IN THE UNITED STATES PATENTAND TRADEMARK OFFICE

Serial No. 09/509,433

OPTICAL IRRADIATION DEVICE

MARKED UP COPY OF SPECIFICATION AND CLAIM 20

FIG. 4

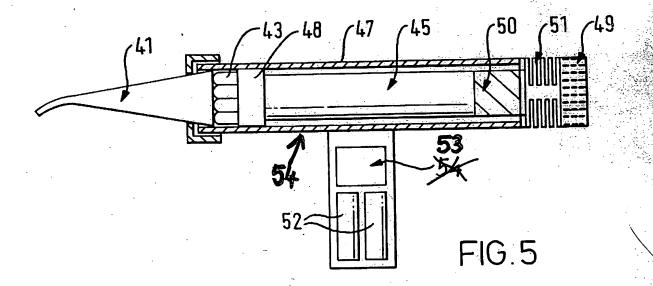
Reference Character 44:

The applicant has amended the text on page 9, lines 6 and 7 so as to delete the reference to "negative lead frame" and "position lead frame". Instead, the lead frames 44 are qualified in terms of their connection to a negative terminal or positive terminal of the LEDs. No change is therefore needed in Figure 4.

FIG.6

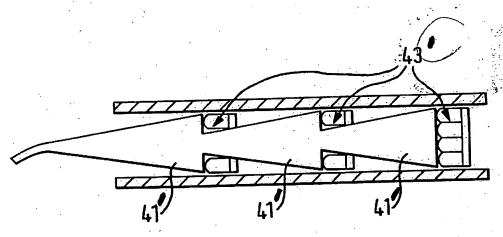
The reference numeral 41 has been changed on page 10, line 4, and in Figure 6 so that it is now 41'.

The reference 43 on page 10, line 3, has been changed to 43' and a corresponding change has been made in Figure 6.

In another embodiment of the invention, illustrated in Figure 6, two or more adiabatic tapered light guides [41] 41' are arranged in series, each with a corresponding cluster of LEDs [43] 43', but with successive clusters forming a ring around the end of one light guide as it connects to the next. Alternatively, each successive ring of LEDs 43 may be replaced by just one or a fewer number of LEDs. This arrangement allows the overall diameter of the device to be kept relatively small as the LED clusters 43 are arranged in groups along the length of the device.

FIG.9

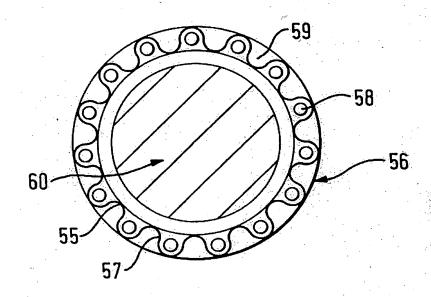
Reference Character 55:

The reference to "inner wall 55" on page 15, line 8, has been changed to "the inner tube 55".

By designing the heat pipe in this way batteries, capacitors, supercapacitors or other energy source 60 can be located within the inner [wall] <u>tube</u> 55 of the heat pipe.
